# JIM PAPAS DRAFTING PTY. LTD.

**RE: OCEAN BREEZE ESTATE AT COOYA BEACH ROAD, BOONIE DOON via MOSSMAN  
RESPONSE TO YOUR REQUEST FOR FURTHER INFORMATION  
(Your Ref. 8/10/157 (3978424))**

SCALE (AT A1 SIZE)	HOR 1:500	DRAWN	J.P.
DATE	APRIL 2013	DESIGNED	J.P.
APPROVED	B. J. SMITH RPEO No. 9326		
DWG NUMBER	1253 - C04	AMDT	B

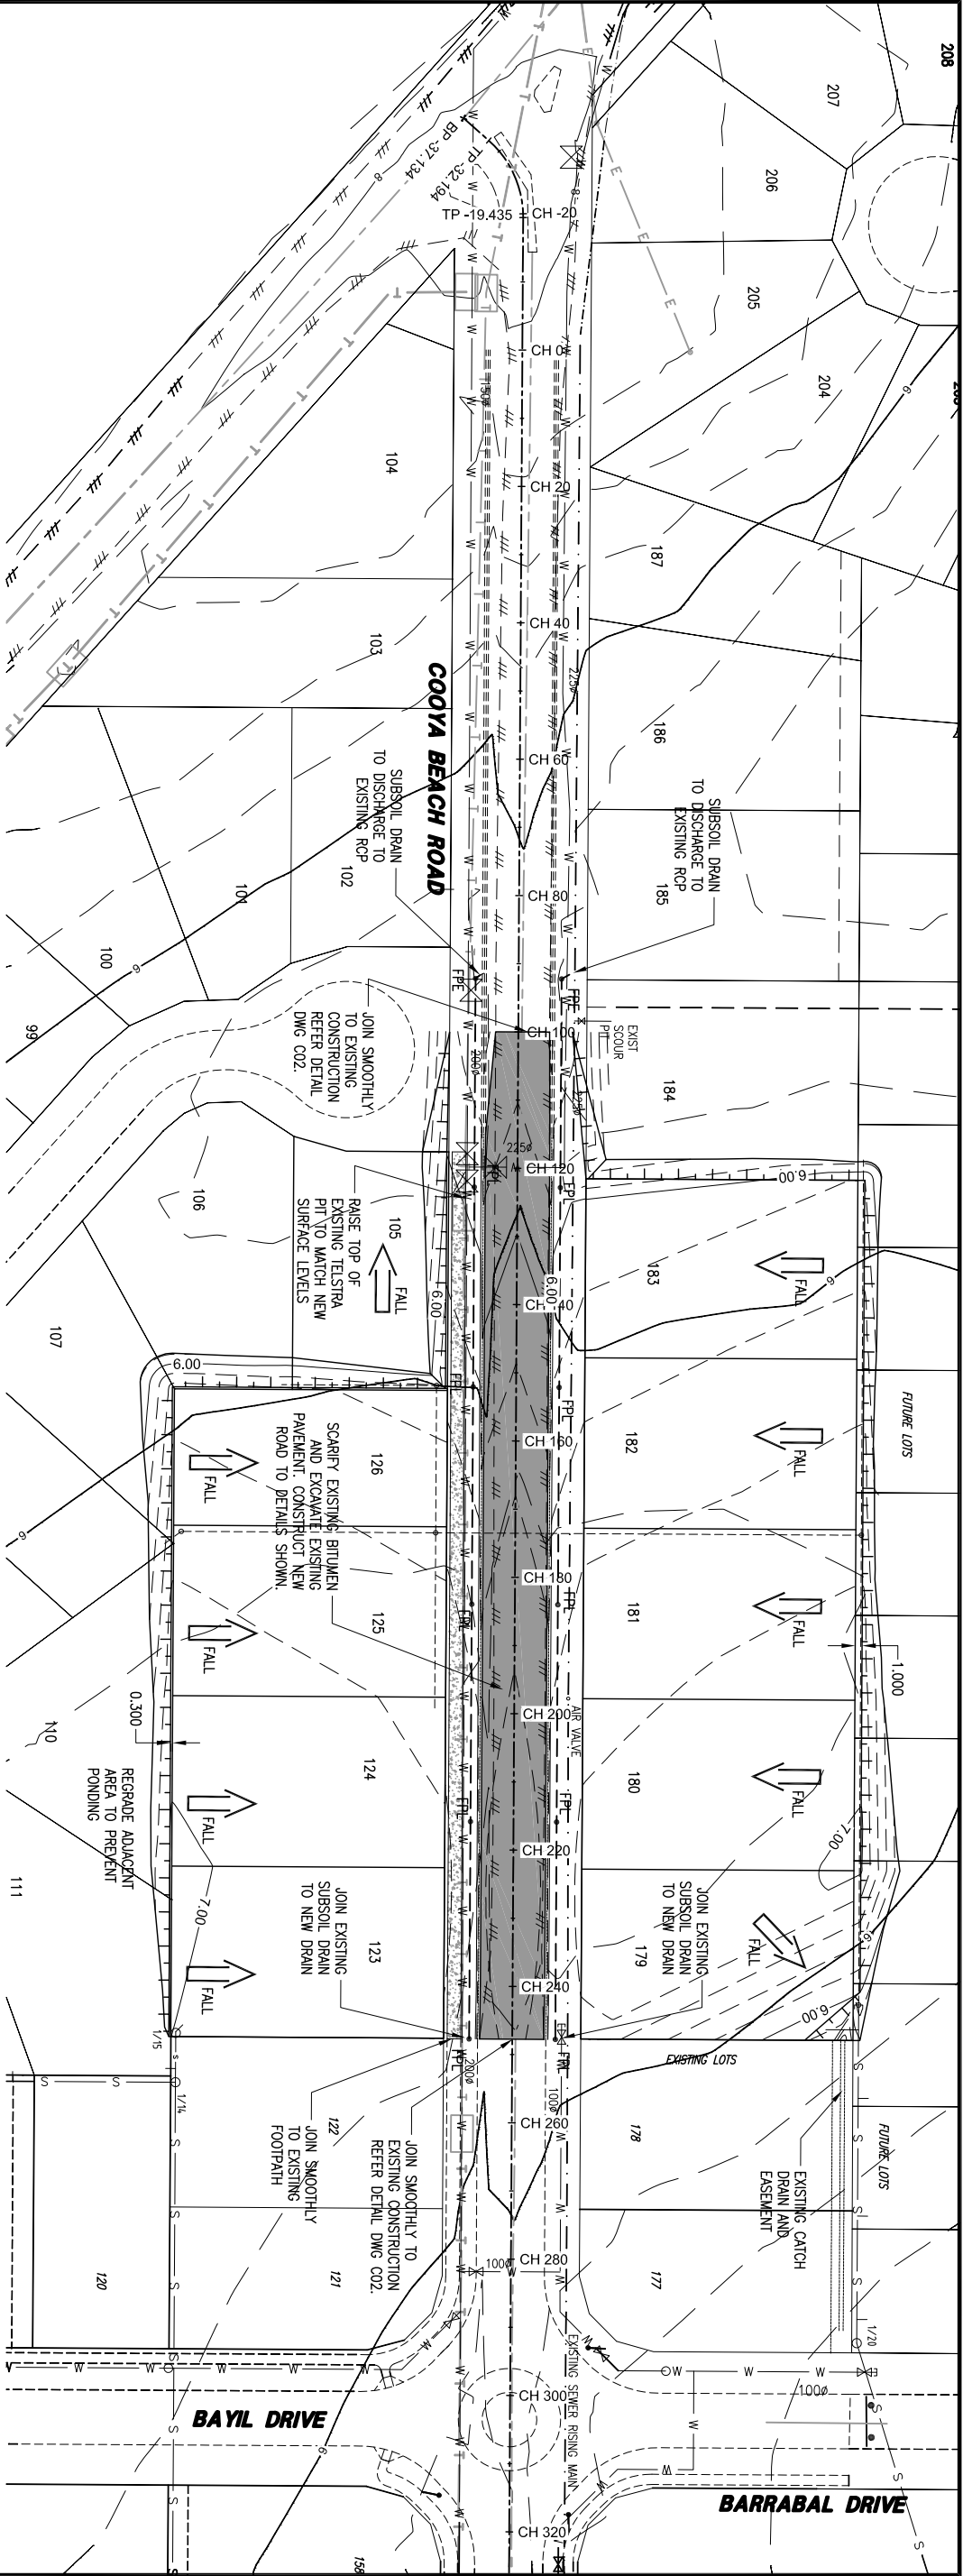
*b. Proposed Lot 105 is not included on drawings – Bulk Earthworks Plan – 1253-C03 Rev (A), Earthworks and Roadworks Plan – 1253 – C04 Rev (A), and Soil & Water Management Plan – 1253 – C05 Rev (A); therefore, the Applicant is to confirm if this Lot will be part of this application, and if so, details will need to be included on these drawings.*

*a. No erosion & sediment control measures are indicated in the existing catch drain at the rear of lots 177 & 178. The applicant is to install ESC measures to the drain (i.e., sediment traps, check dams) to ensure sediment is not released from the site during construction. All existing kerb inlets in Bayil Drive and Cooya Beach Rd must be protected with sediment traps. Amended drawings are to be supplied for approval.”*

*"c Connect the proposed 100dia water main to the existing 225dia water main at in the vicinity of Lot 184."*

The drawings have been amended to show the earthworks and other details appropriate to construction of this lot.

The drawings have been amended to show the required detail.

We have amended the drawings to show this connection.

A	ORIGINAL ISSUE FOR OPERATIONAL WORKS APPROVAL	03.04.13
B	EARTHWORKS ADDED TO LOT 105	28.06.13

DWG NUMBER: 1253 - C07

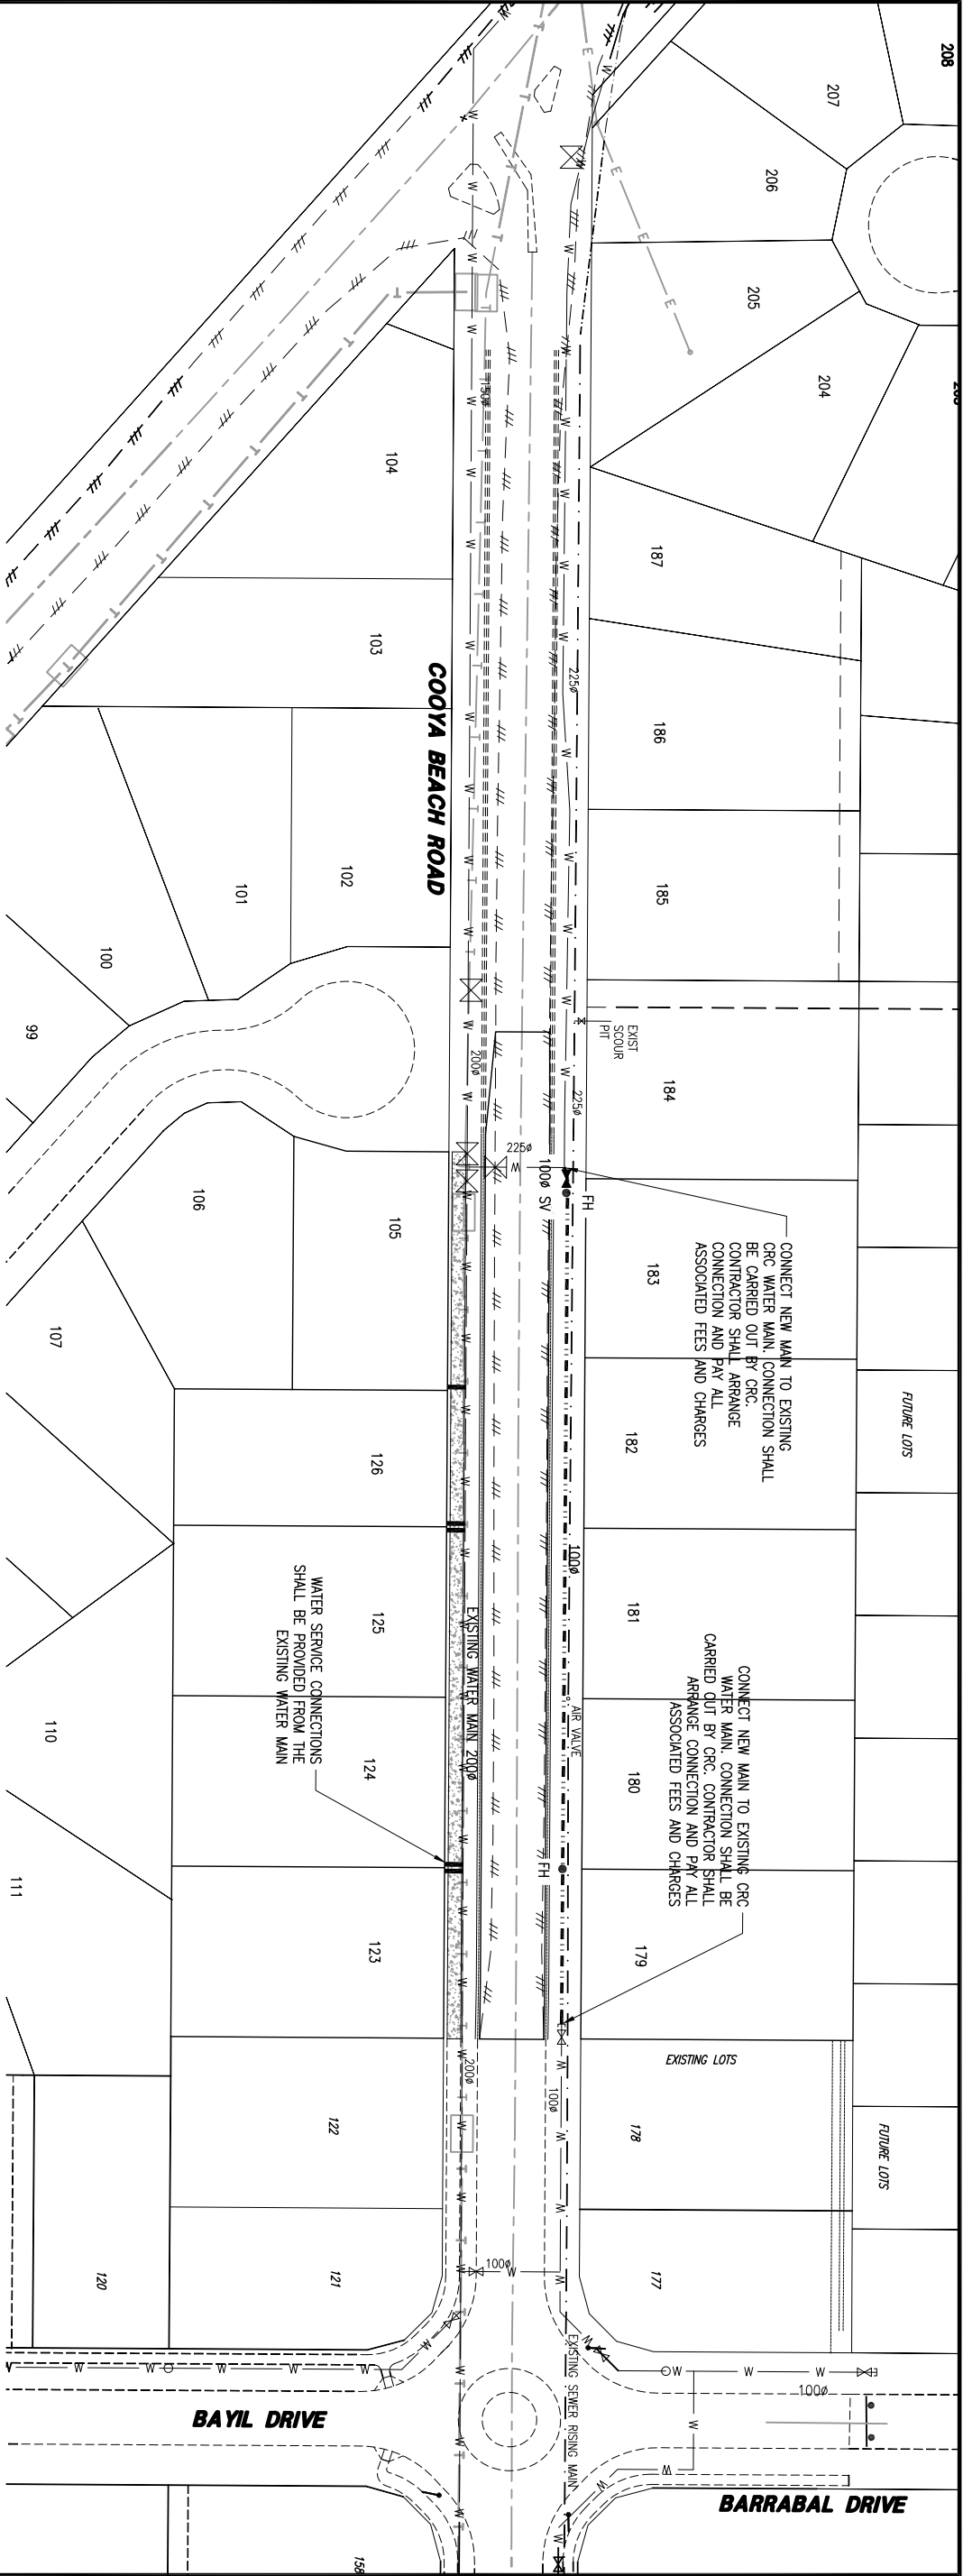
*“b Show the existing 225dia water main along Cooya Beach Road at the frontage of Lot 184 on drawing.*

*"e Provide an updated water master plan drawing 1187- 0A Water - (B) reflecting the proposed water main configuration and current boundary conditions. It was noted that the existing 225dia water main is not shown the master plan."*

Council subsequently supplied PDF drawings of the works. We have amended the drawings to show the new water mains. We note that the date on the "As Constructed" is February 2012. We are very disappointed that Council did not see fit to at least advise us of their plans to construct the water main prior to commencement of works. We note that the water main is not located on a standard alignment and we trust that this construction does not compromise future construction associated with the development of Ocean Breeze Estate.

We have amended the drawings to show the new water mains. A copy of these amended drawings is included in amended water reticulation report.

A	ORIGINAL, ISSUE FOR OPERATIONAL WORKS APPROVAL	03.04.13
B	225# WATER MAIN ADDED AND NEW WORKS CONNECTED TO THE NEW MAIN	28.06.13
